Technical Service Bulletin

MODEL(S) AFFECTED: **B5, B7, T300e, T300, T500e, T500, T600e and T600**

SUBJECT: Speed control potentiometer failure. Over time, under normal operating use, the potentiometer's adjustable wiper may slowly wear the printed resistive strip due to vibration causing intermittent or complete propel failure.

New Potentiometer (p/n 1246392)

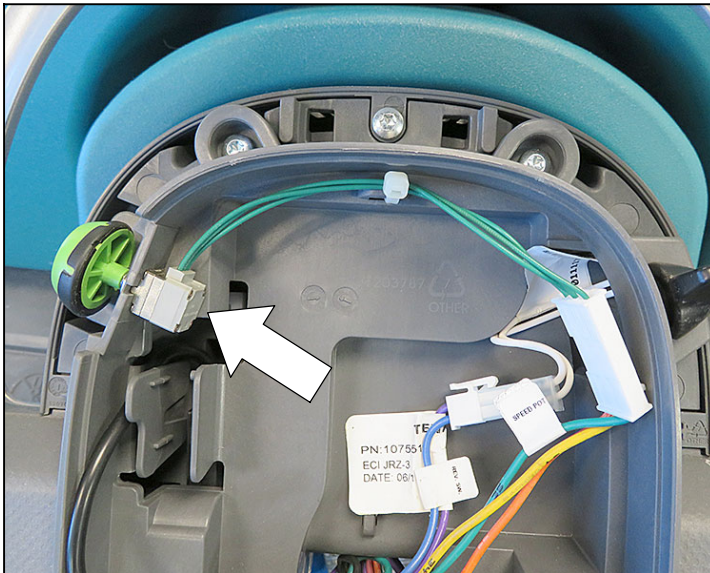
PURPOSE: To repair potentiometer failure, order replacement potentiometer (p/n 1246392). The new potentiometer is more robust and designed with 11 distinct speed settings, making it easier for the operator to select a desired speed by the feel of each speed detent of the dial. The 11 distinct resistive settings are silver pads which provide a longer wear life.

The new potentiometer is a direct replacement. It does not require any specific installation instructions. The wires on the new potentiometer are all black whereas the original potentiometer are green.

Original potentiometer (p/n 1204930) has been discontinued.
